Re: Wilder Dam Project No. 1892
Bellows Falls Project No. 1855
Vernon Dam Project No. 1904

**Connecticut River Conservancy Comments on Great River Hydro, LLC Study Reports filed by
March 15, 2017; Request for Study Modification to Require Compliance with the RSP.**

**Re: FERC Re-Licensing Process for Great River Hydro, LLC
Peer-Review of ILP Study 2 and Study 3
Riverbank Transect and Riverbank Erosion Studies
Final Study Report, dated February 4, 2017**

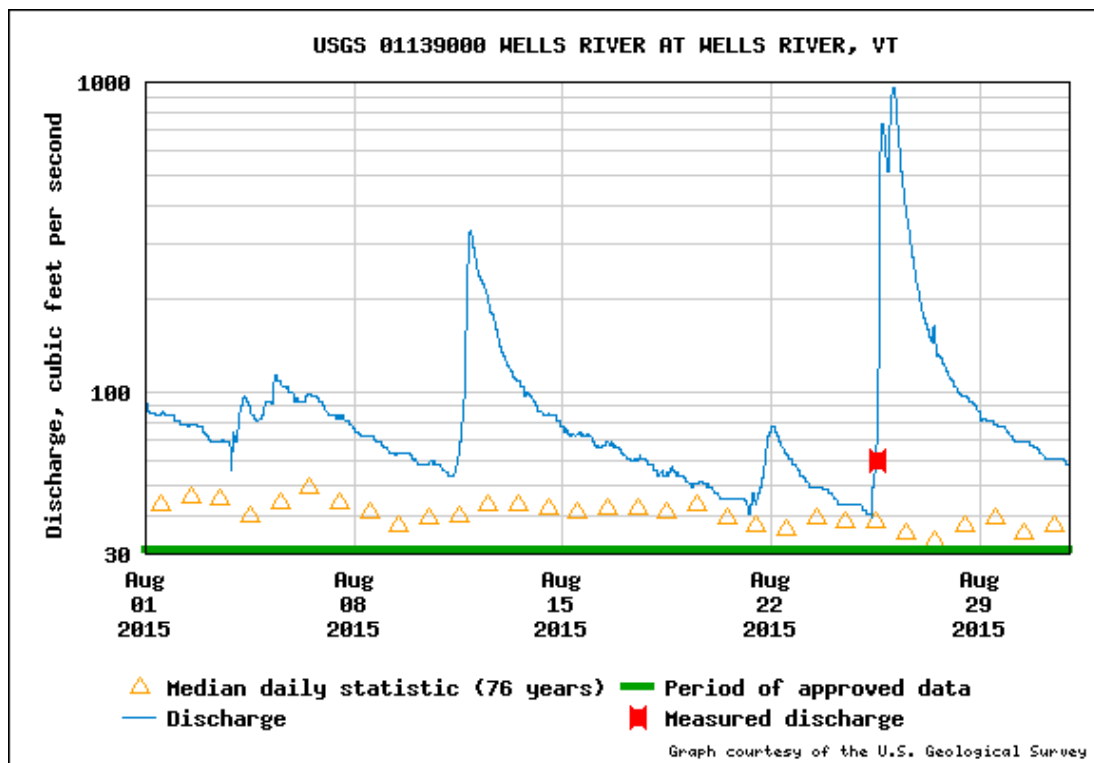
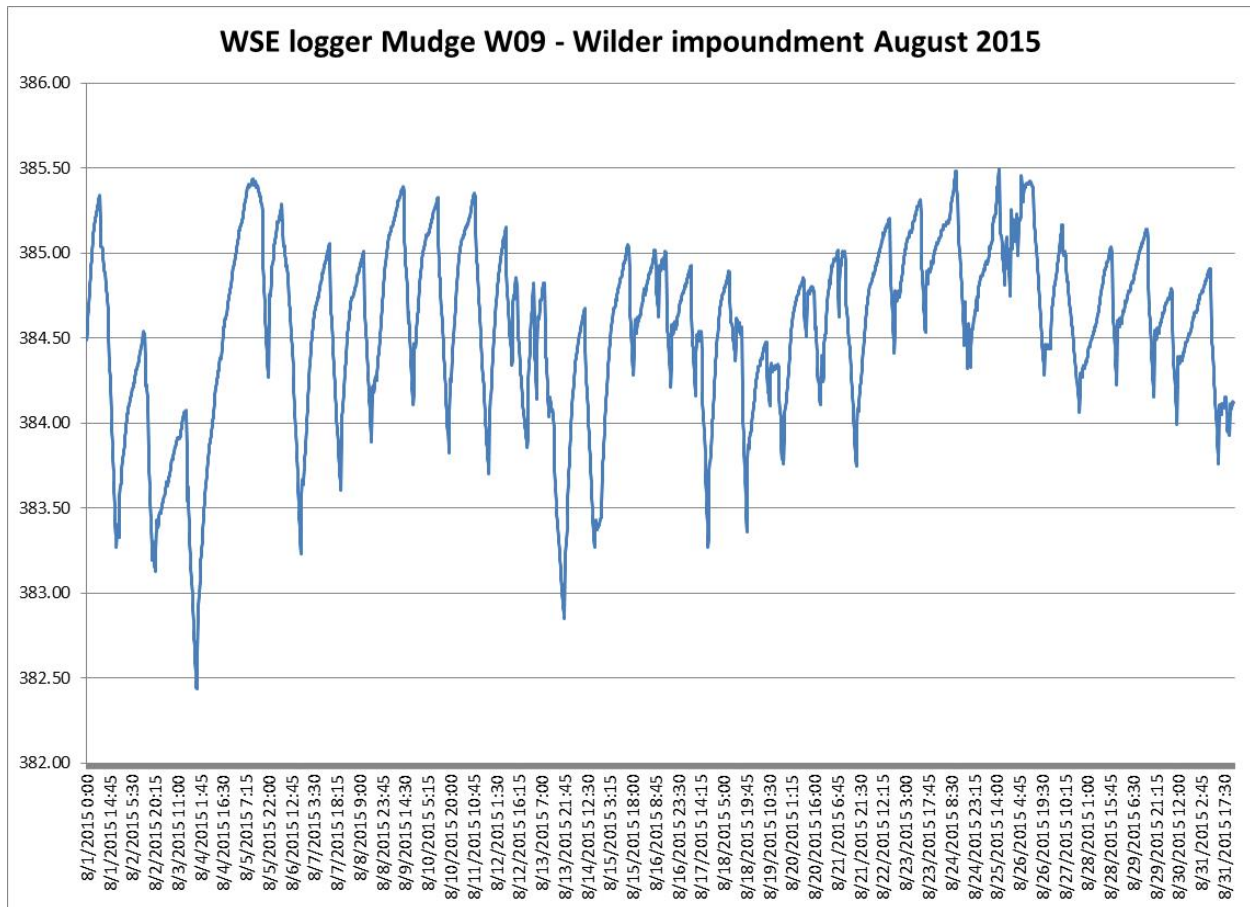
CRC would like to add that exceedance curves for midnight readings do not capture the full scope of "normal operation of the station generation and impoundment storage." There is more to project operations than a midnight elevation of the impoundment. In particular, in the past decade, we have seen deregulation of the electric industry, sales of hydropower assets to international companies and investment firms, and retirement of some of the larger coal and nuclear power plants in the region. The changing energy market *could* result in more hydropower peaking and therefore higher sub-daily fluctuations of impoundments or multiple peaks per day. The report contains no information on trends in operations leading to sub-daily changes, and TransCanada states on page 133 (also stated at the

4. WSE Fluctuations

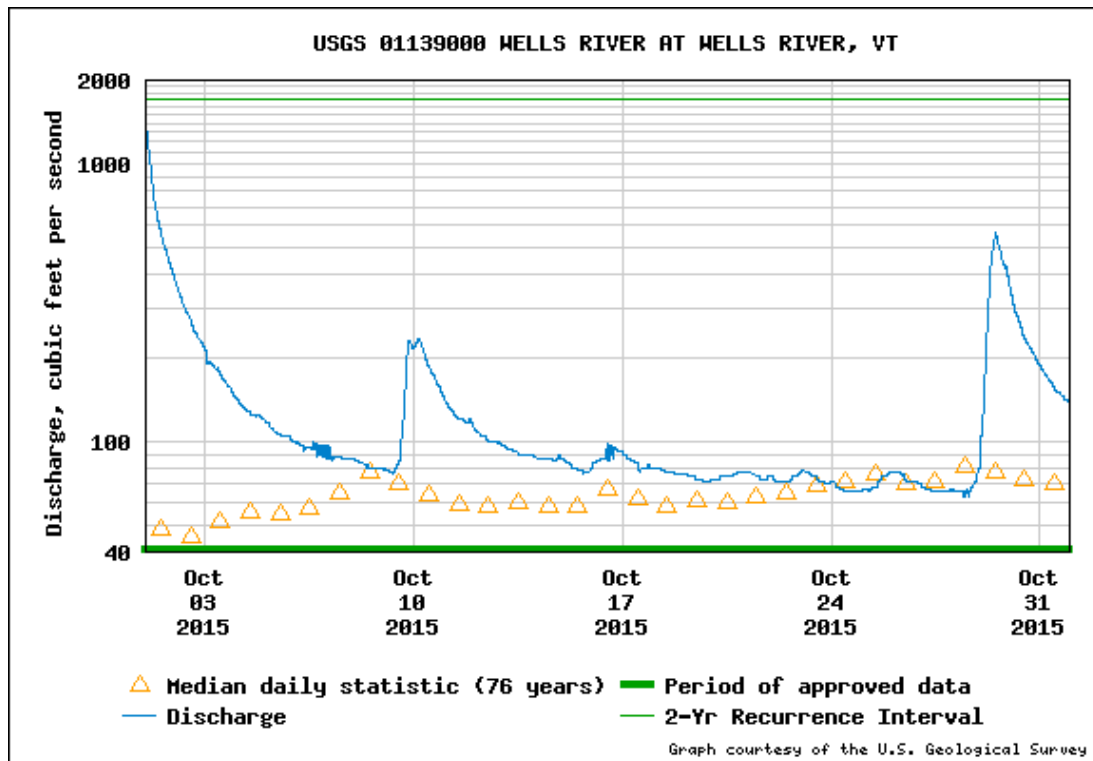
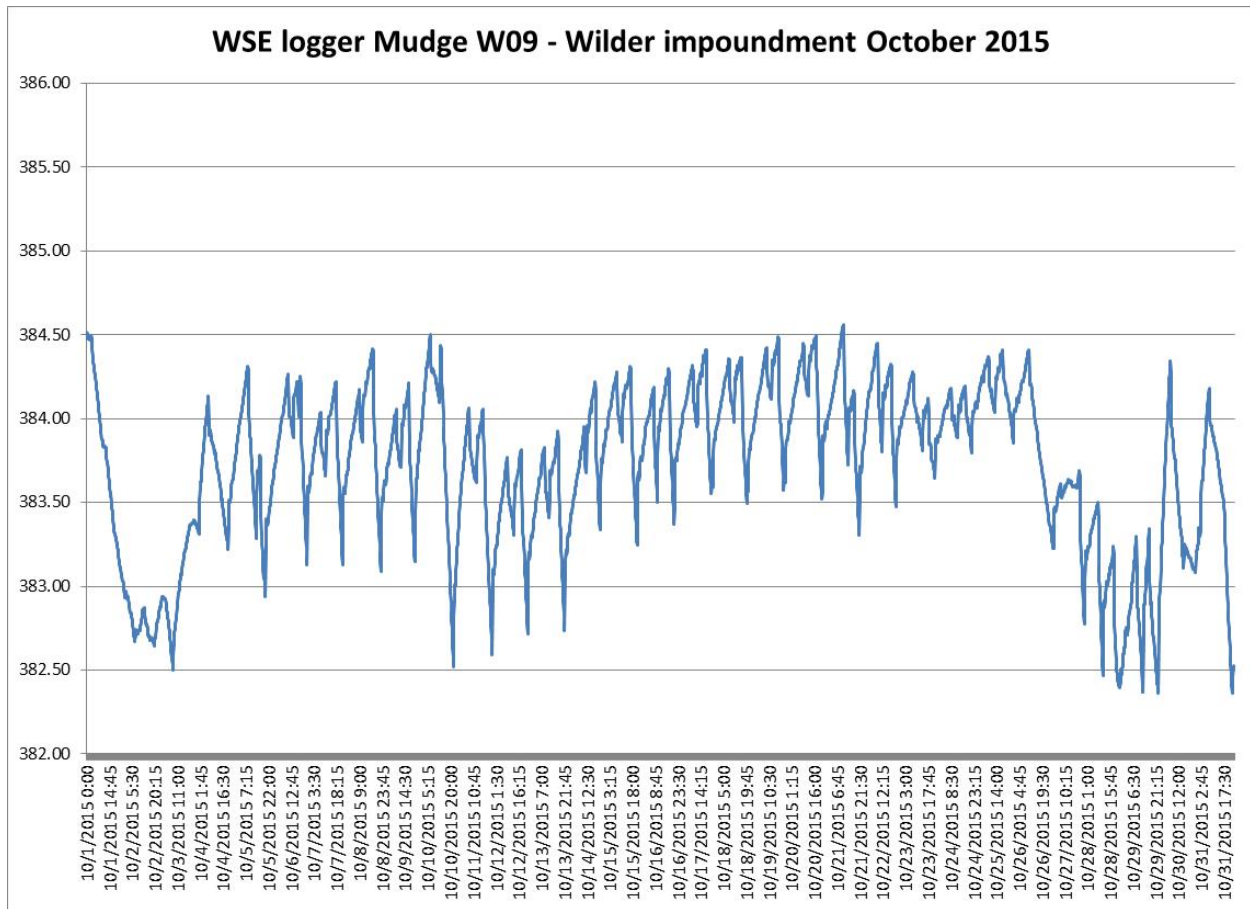
Appendix A contained river stage profiles for the 21 transects, showing the median WSE fluctuation zone compared to the river bank profile. Table 4 in Appendix E shows the bins of the median fluctuation ranges. It is notable that though the report often states how project operations result in a fairly narrow fluctuation range, data in Table 4 of Appendix E show that the riverbank lengths associated with median fluctuations of between 4 and 7 ft add up to 193,803 ft or 36.7 miles of bank.

TransCanada provided logger data to stakeholders, which helps us understand the nature of river fluctuations better than exceedance curves or shaded bands on a bank. The graphs below have been made using the WSE logger data provided by TransCanada that were installed for Study 2 and 3, using one site for example purposes. The graphs show how water levels at the Wilder impoundment transect site, Mudge W09, varied in August and October 2015. In August, the river elevations varied between 383 and 385.5 ft, whereas in October, the river elevations never exceeded 384.5 ft, with two peaks per day being common. It also appears that midnight is a time when the river levels are steeply rising, as the impoundments are being re-filled to get ready for the next day's generation period. Below each graph shows the USGS gage for the corresponding month at the Wells River, VT site, approximately 50 miles upstream of the Wilder Dam but downstream of the next upstream dam (Ryegate Dam).

The TransCanada RSP for Study 2 stated that, "Relationships observed between changing water levels and the timing of bank erosion will help establish whether water-level fluctuations, described in terms of magnitude, periodicity and duration, and increased shear stresses resulting from project operations are correlated with erosion in project-affected areas." Overall, Great River Hydro has provided information indicating that high flow events are the dominant cause of erosion along the banks of the Connecticut River impacted by the operation of Wilder, Bellows Falls, and Vernon Dams. However, project operational effects have mostly gone unassessed. If you examine the graphs provided below, CRC maintains that the operation of the dams cause river fluctuations that are far from that of a natural river. The study report has looked at the magnitude of water level fluctuations, but not the periodicity and duration of water level fluctuations, and shear stresses from project operations have only been looked at for the upper end. Sub-daily fluctuations will undoubtedly have some effect on bank stability, and it may not be entirely due to changes in shear stress. Our understanding of the degree of influence of these fluctuations has not been appreciably advanced by this study. CRC requests that these studies be modified pursuant to 18 C.F.R. § 5.15(a) and (d) (1) to fully address these comments. In lieu of fixing the problems with the study, we may also need to just proceed with a gap in understanding. To the extent possible we will recommend operational changes to reduce river fluctuations, and in lieu of that we will be recommending elements of a plan to mitigate the impact of project operations.
